1965 Corvette: Service Bulletin: Transistorized Voltage Regulator Failures

Subject: Transistorized Voltage Regulator Failures

Bulletin Number: TSB #1115, Section VIy

Date: April 12, 1965

FIGURE 1 - DIODE AND WIRE ASSEMBLY (PART #2988198) INSTALLATION

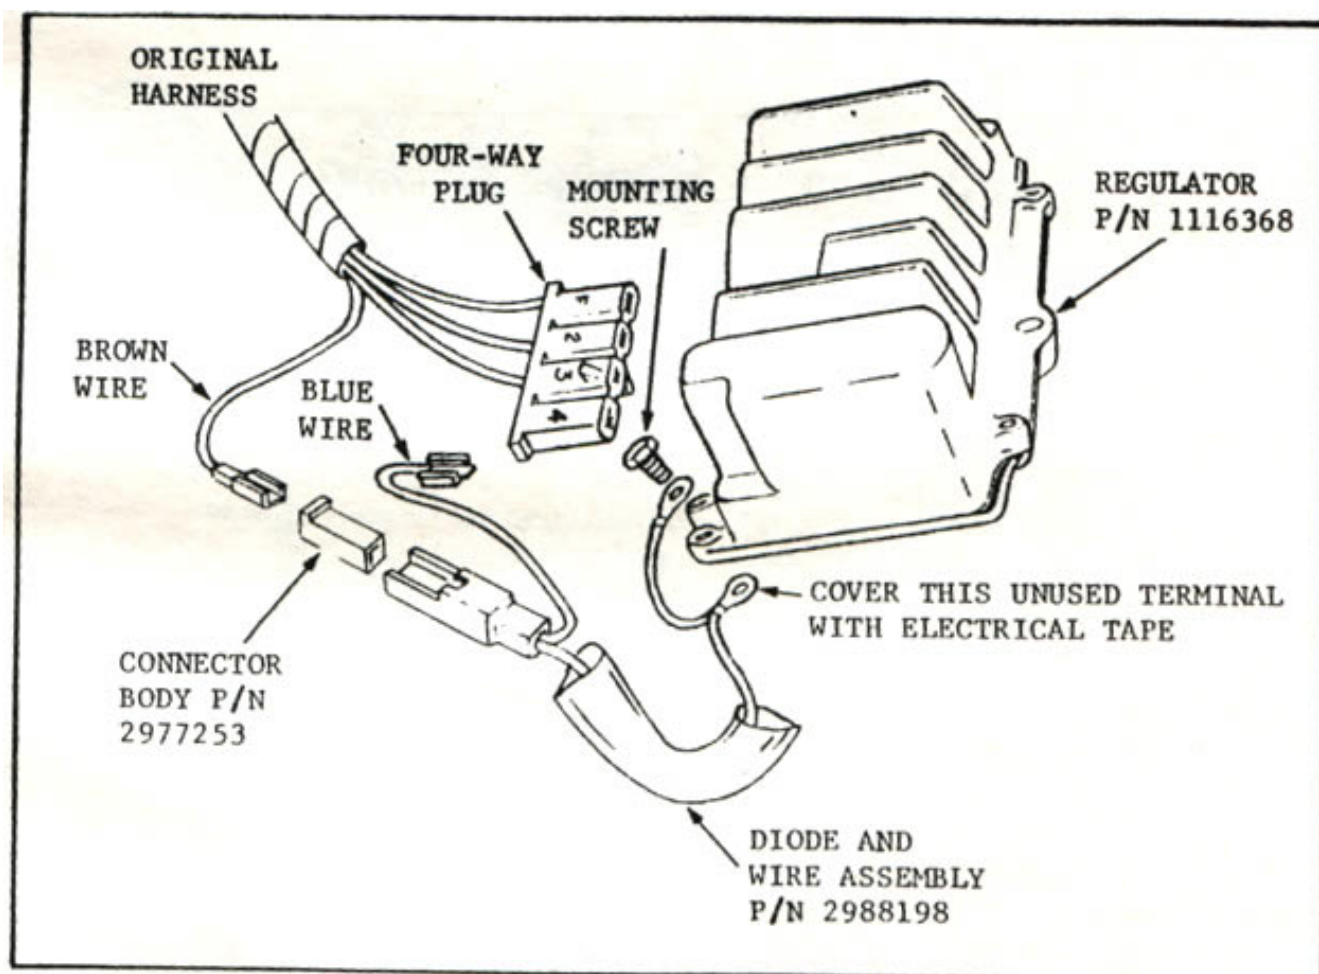
without apparent cause, the problem may be the result of excessive reverse voltage surges generated by heater or air conditioning blower motor, power window motors, etc. when the ignition switch is moved to the "off" position. To provide a ground path for such transient voltages when installing the replacement regulator, install a suppression diode as outlined below.

1. Disconnect battery ground cable.
2. Remove four-way plug from regulator and remove regulator.
3. Remove the brown wire from the #4 location in the plug by using a small thin bladed tool to release the lock tang.
4. Obtain a Part #2988198 wire and diode assembly, and insert the spade terminal from the short blue wire into the #4 location in the regulator plug.
5. Reform the lock tang on the spade terminal of the brown wire (previously removed from the #4 position) and install a Part No. 2977253 connector body over the terminal. Plug this connector into the receptacle of the wire and diode assembly.

6. Install the regulator with the black ground "pig tail" attached by one of the mounting bolts (see fig. 1).
7. Cover the unused ground terminal of the diode lead (double black wires) with electrical tape.
8. Reinstall the regulator plug and the battery ground cable.
